ADDENDUM #1
RFP #16-14
Pawtucket Falls Overlook

Project Concept and Design

SHEET NO. L1.1

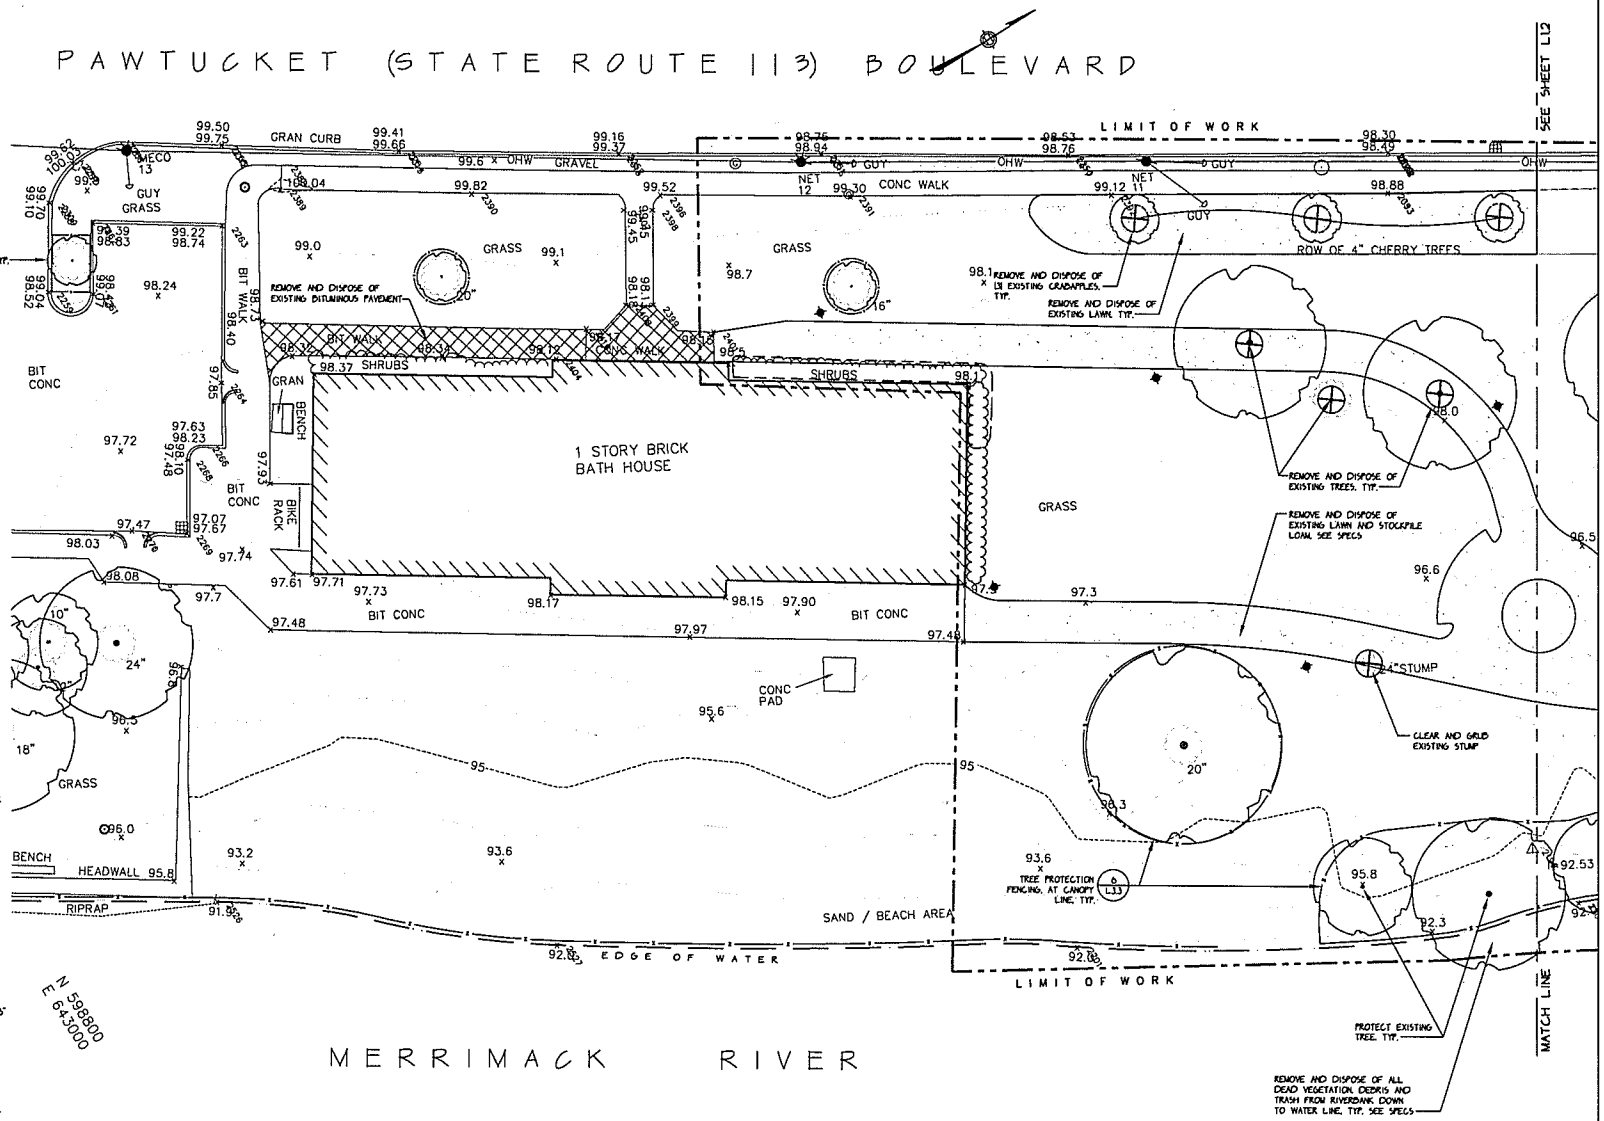
Is it possible to re-issue drawing L1.1 as it is corrupted and cannot be opened or viewed?

Yes, please find attached.

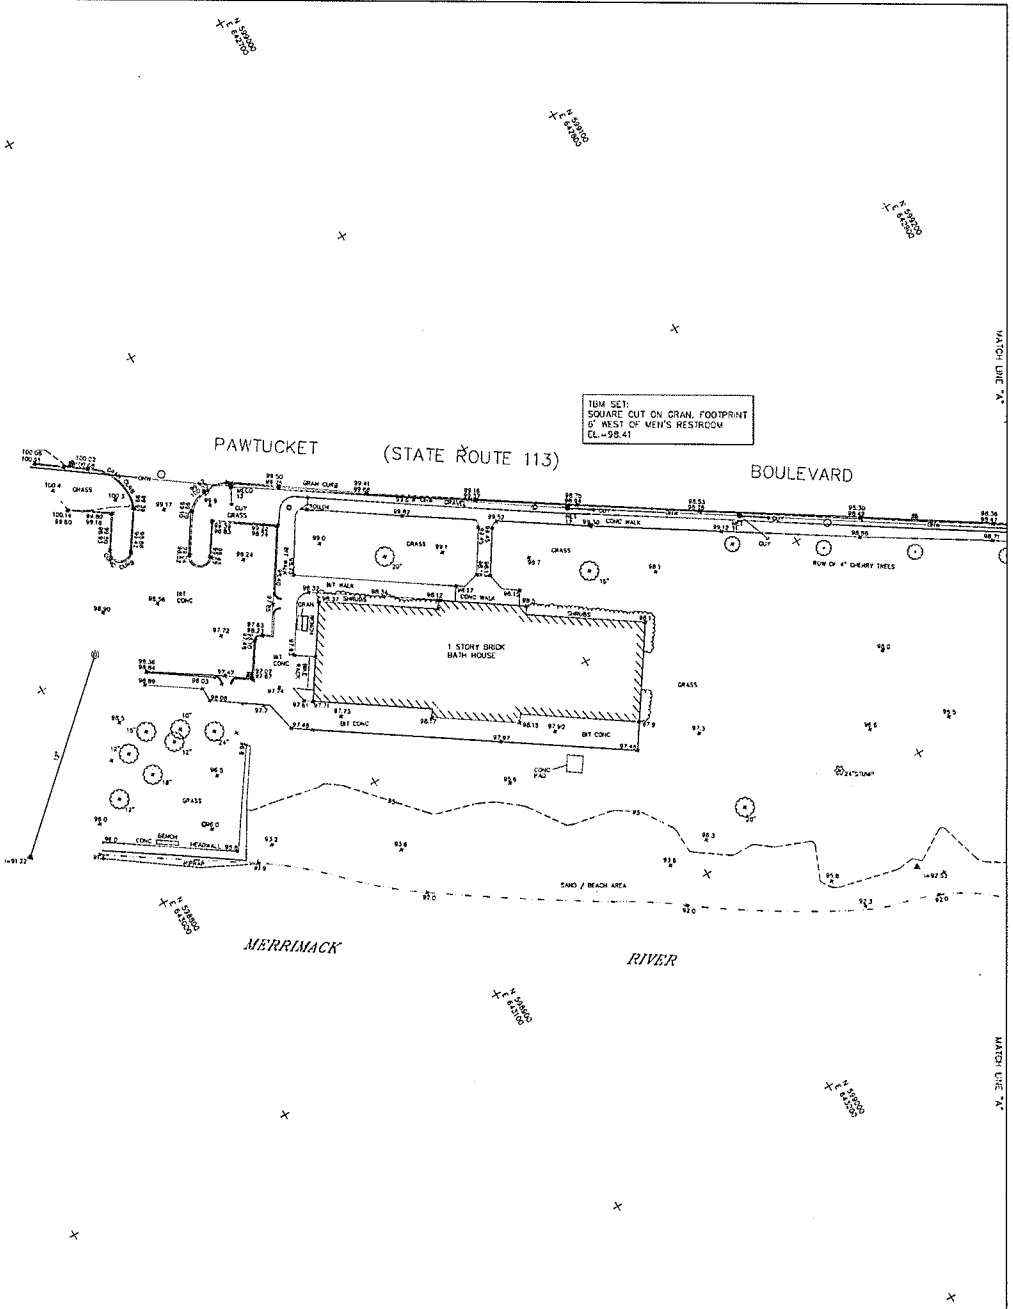
Are there existing base plans available that provide all of the appropriate references and notes?

Have wetland resources been flagged? If so when were they last flagged? Depending on that date do they need to be to be re-flagged? Have any Bordering Vegetated Wetlands and/or River Bank been delineated and survey located?

Drawings P1-P5 (attached) are PDF files of the existing topo base plans. All notes and references available are on those drawings. If relevant to the new effort, the CAD file of the topo will be furnished to the selected consultant.

The only known survey location of the river bank is in drawings P1-P5 (attached). A new survey may be undertaken as part of the project at the consultant's discretion, in which case, wetland resources may need to be re-flagged. However, no construction at or very close to the riverbank is anticipated as part of this project.
